## **Access Compliance Report Public Rights-of-Way** (Curb Ramps)

Intersection ID: 11225 Main Street: ELKWOOD\_CR Cross Street: SHAMROCK\_DR Location: W Severity Score: **Overall Compliance: No** ADA ID: 830627C86F48 Ramp Type: Perp Initial Pass/Fail: Fail 22.5

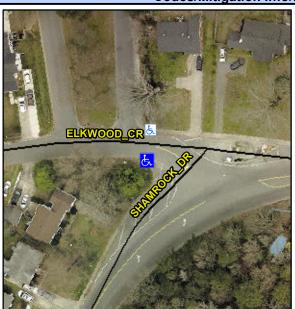
1 CCCIDIC CCIGGICI	
Possible Solutions:	
Remove & Replace Entire Ramp.	
	I
Surveyor Notes:	
N/A	
PROW/ADA:	
Not Found, R304.5.1, R304.2.2,	
R304.5.3

Field Measurements/Component Compliance							
Comp	liance Description	Data	Comp	liance Description	Data		
N/A	Ramp Length (in)	56.0	No	Ramp Slope (%)	9.0		
No	Ramp Width (in)	46.0	No	Ramp XSlope (%)	3.3		
N/A	Flare Type LT	N/A	N/A	Flare Type RT	N/A		
N/A	Flare Slope LT (%)	N/A	N/A	Flare Slope RT (%)	N/A		
N/A	Flare Traversable LT?	N/A	N/A	Flare Traversable RT?	N/A		
N/A	Landing Length (in)	N/A	N/A	DWS Provided?	N/A		
N/A	Landing Width (in)	N/A	N/A	DWS Contrast?	N/A		
N/A	Landing Slope (%)	N/A	N/A	DWS Length (in)	N/A		
N/A	Landing X Slope (%)	N/A	N/A	DWS Full Width?	N/A		
N/A	Landing Curb? (Y/N)	N/A	N/A	DWS Offset (in)	N/A		
N/A	Shared Landing?	N/A					
N/A	Gutter Ponding?	N/A	N/A	Gutter Slope (%)	N/A		
N/A	Gutter Lip Ht (in)	N/A	N/A	Gutter X Slope (%)	N/A		
N/A	Painted X Walk1?	No	N/A	Painted X Walk2?	N/A		
	X Walk 1 Direction	To NE		X Walk 2 Direction	N/A		
N/A	X Walk 1 Width (in)	N/A	N/A	X Walk 2 Width (in)	N/A
